MOOLARBEN COAL COMPLEX STAGE 1 (05_0117) – UG4 ANCILLARY WORKS MODIFICATION (05_0117 MOD 15)

Moolarben Coal Operations Pty Ltd (MCO) has reviewed the additional response from Transport for New South Wales (TfNSW) (dated 18 February 2020) and notes the recommendation made regarding the Ulan Road/ Saddlers Creek Road intersection.

Chart 1: Northern Dewatering Sites – Indicative Peak Heavy Vehicles Per Day

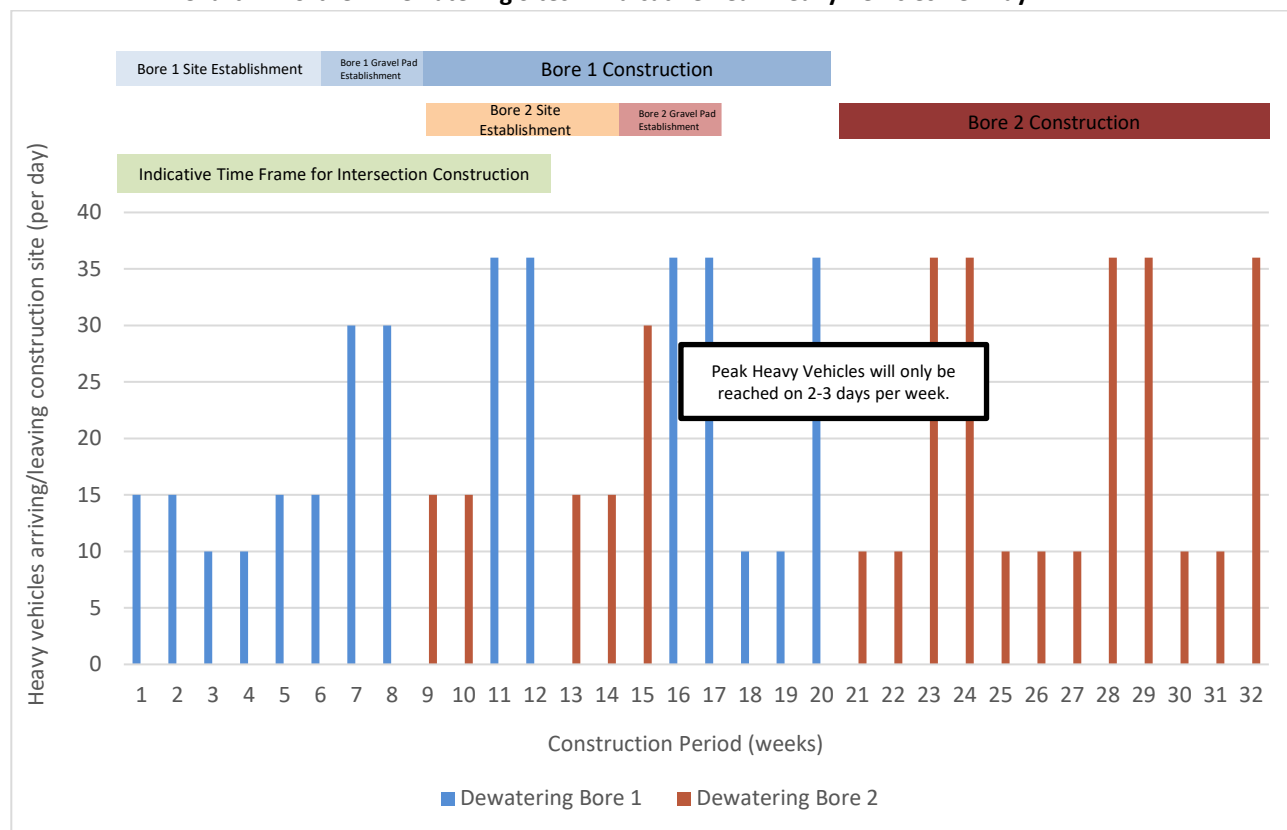
- Consistent with the description in Section 2.4 of the Modification Report, construction of the northern dewatering sites is anticipated to commence in 2026, and would occur over an estimated 32-week period, including (Chart 1) approximately:
 - Up to 8 weeks for site establishment; and
 - Up to 12 weeks for construction for each bore.
- Chart 1 provides an indicative breakdown of the proposed heavy vehicle movements over the construction period.
- As noted on Chart 1, the peak heavy vehicle movements would likely only be required on 2-3 days out of each week.
